KMR.CDD.MmQ.1938.06

**MUNICIPAL CORPORATION  
KARACHI.**

Reference No. B. S. P. 340/38

MODIFIED PLAN OF PROPOSED BUILDING  
ON PLOT NO 28+30, SHEET NO M.M.3,  
MUCCHHI MIANI QR.  
SCALE 8 FT. TO 1 IN.

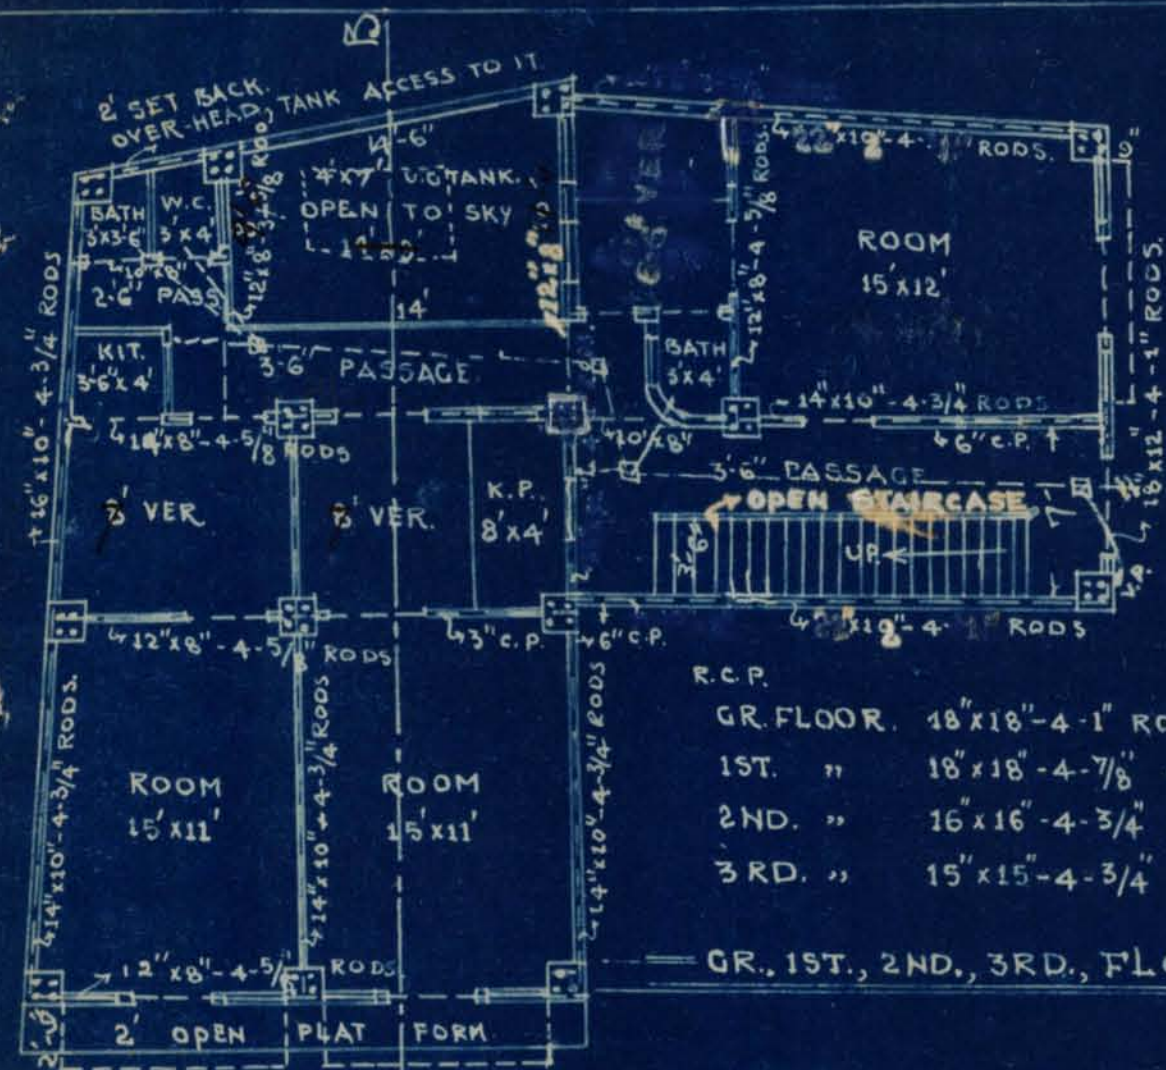
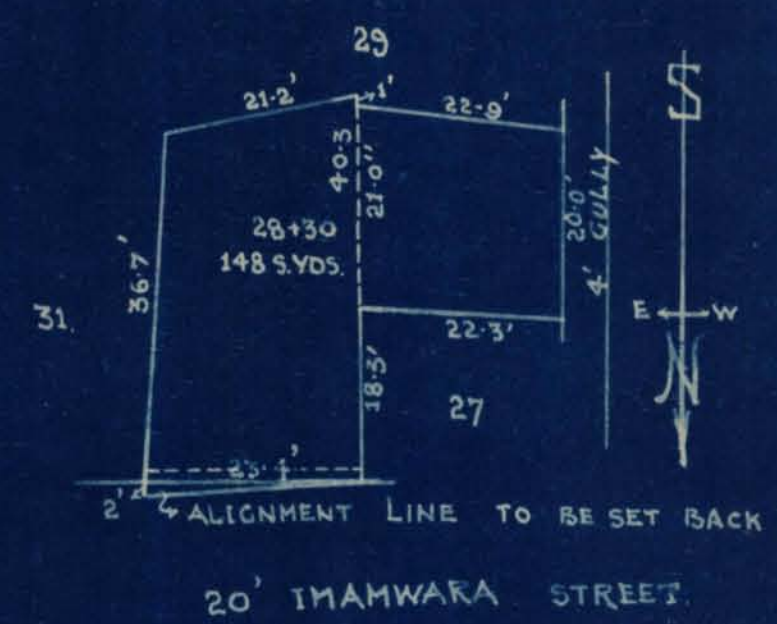
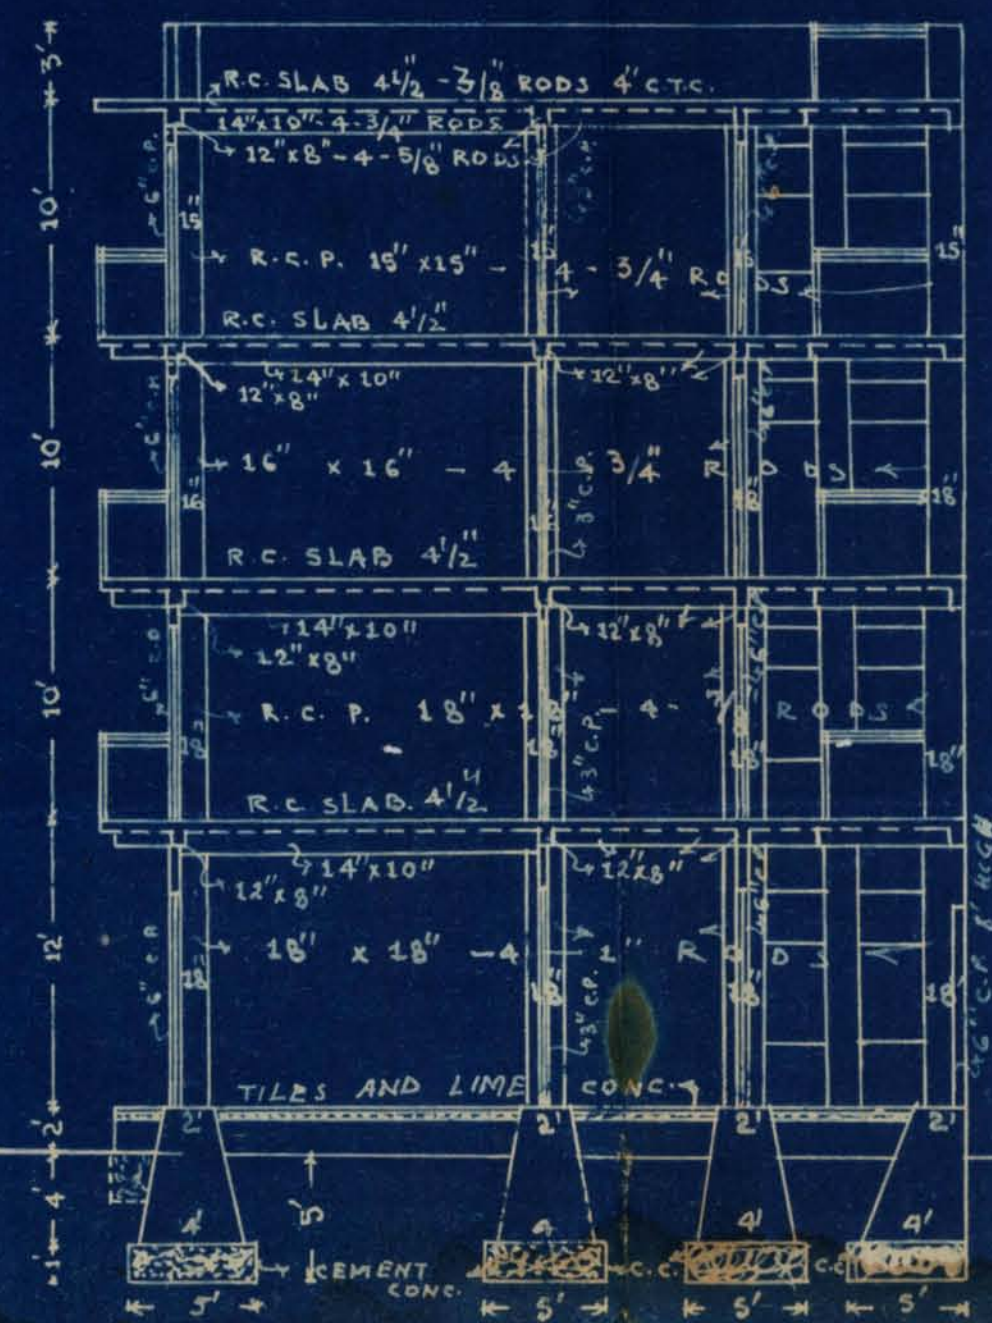
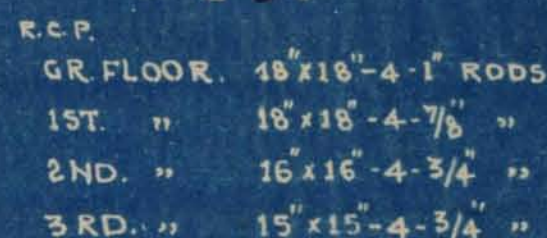
The H.O. has no objection now  
and so also the L.S. (vide letter  
dt. 2/11/38 & L.S. dt. 31/10/38)

These were the only objections remaining

Plans approved

PLAN OF PROPOSED BUILDING ON PLOT N<sup>o</sup> 28+30  
SHEET N<sup>o</sup> M.M.3. MUCHHI MIANI QR  
SCALE 8 FT. TO AN INCH

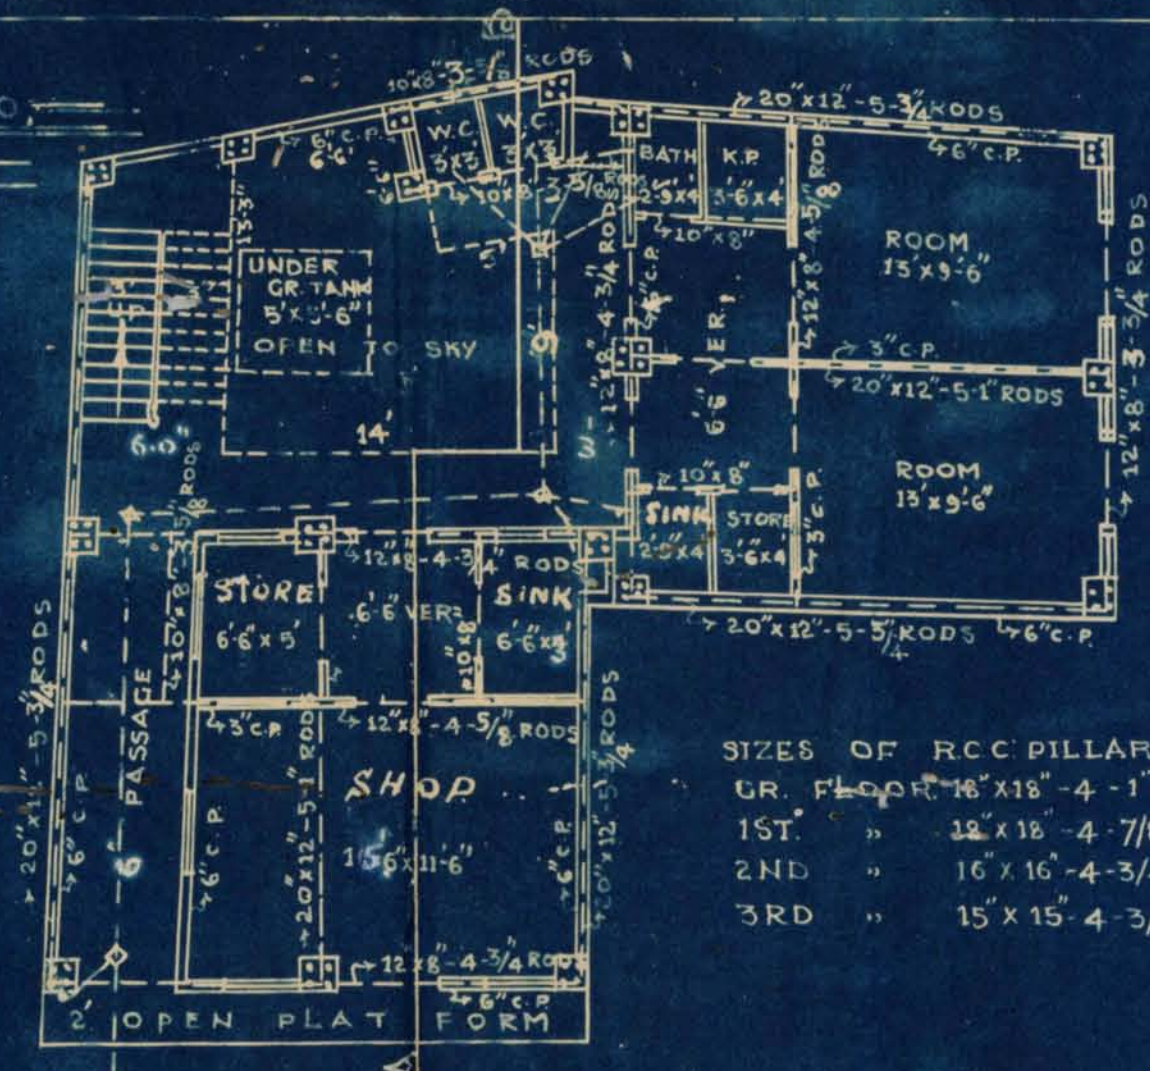
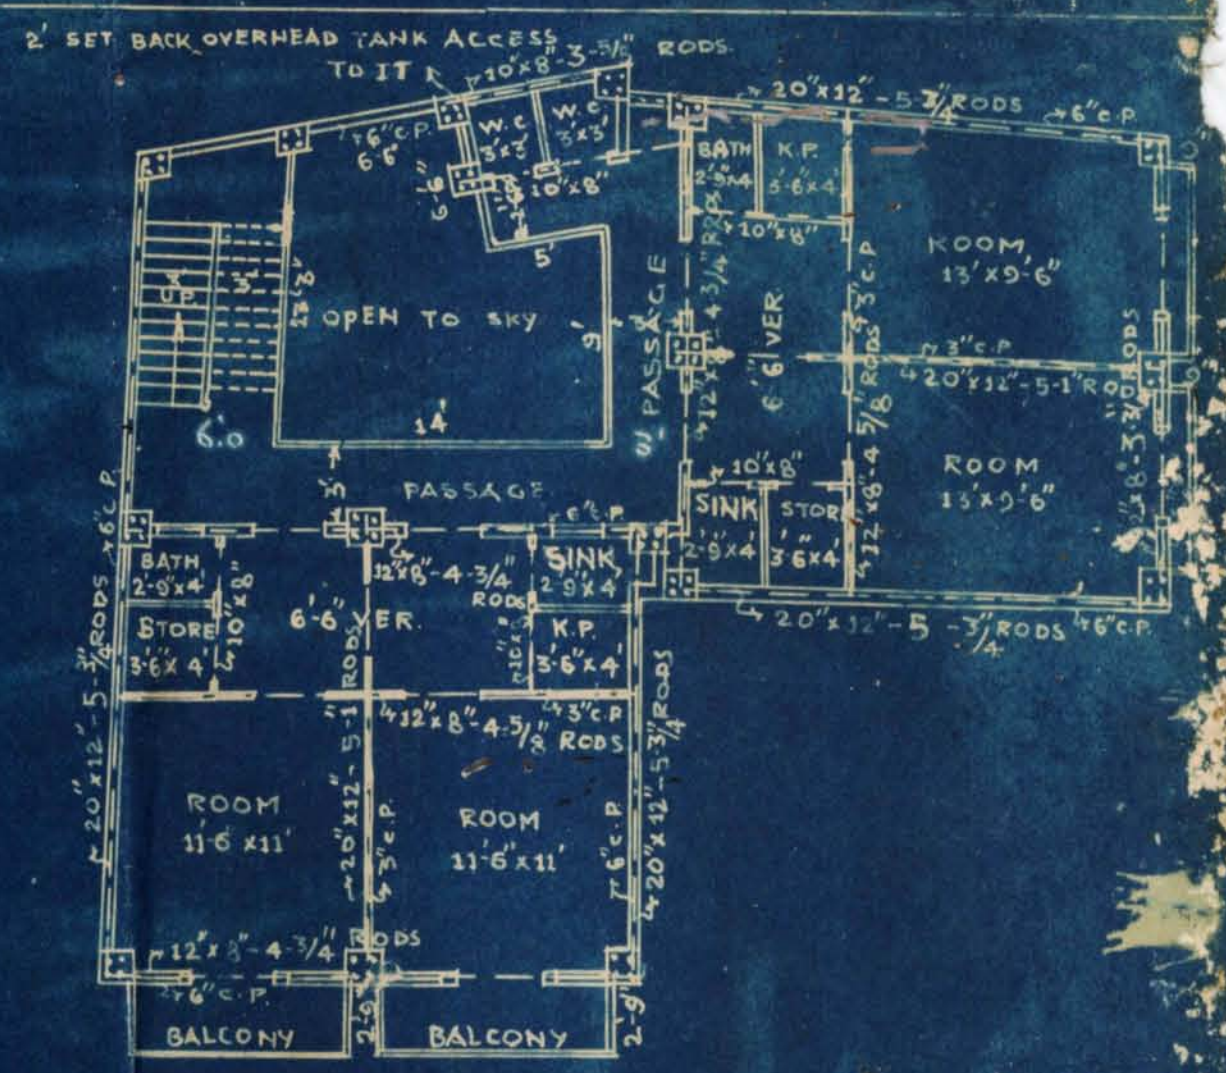
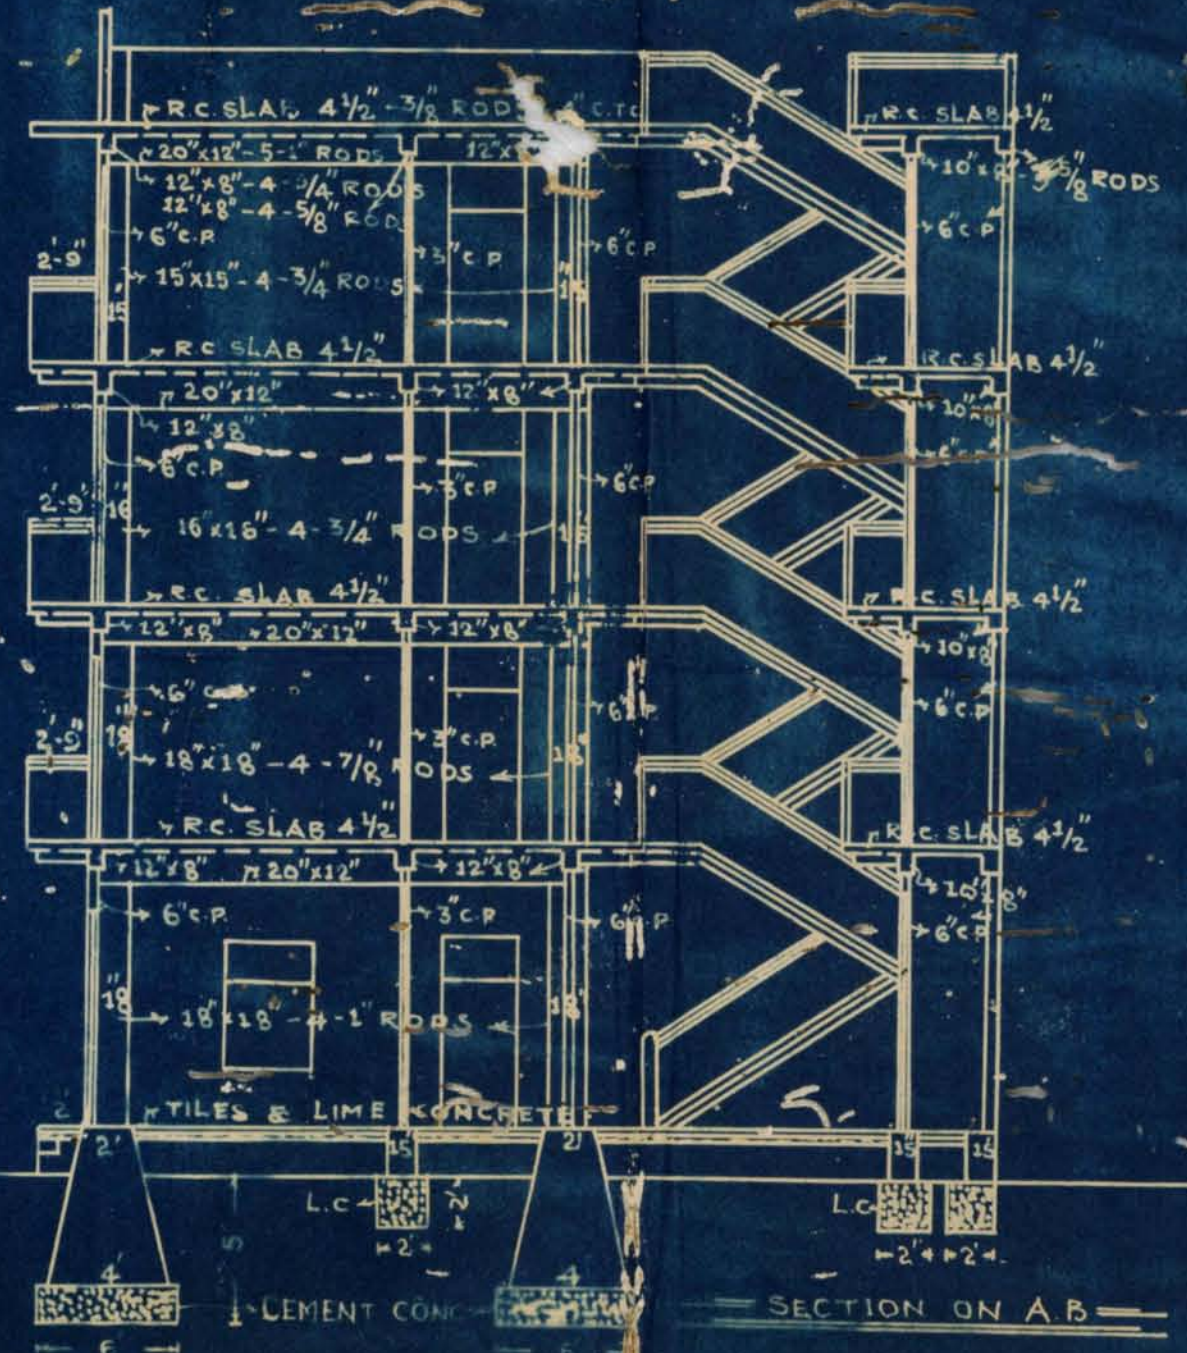
The Architect has re-submitted the plans after complying with some of the requirements. Re: B.S.'s requir. no 1. The street width as reported by the L.S. is 20' 0 and the owner proposes to leave 2' 0 of his own land and thus he wants to take advantage of this proposing his building 14' high from R.D. level.

Re: no 2. This objection is removed and the Tenements are now proposed instead of 4 as before as shown.

Re: no 3. The internal open space is now proposed 14' 0 as shown.

Re: no 4. The base of foundation of R.C.C. pillar is increased to 6' x 6' instead of 5' x 5' as before.

No 5. Complied with and as regards no. 6 reinforcement is now increased.

The S.E. has no objection but only H.O.'s and L.S.'s requirements remain. Also site plan requires corrections.

(1) The open area is widened from 12' x 14' x 9' and it is according to the rules and regulation. The open is increased by 27'.

(2) The plan for amalgamation has also been forwarded to the C.D.C. and will be sanctioned in near future in the meantime kindly approve the plan subject to the amalgamation.
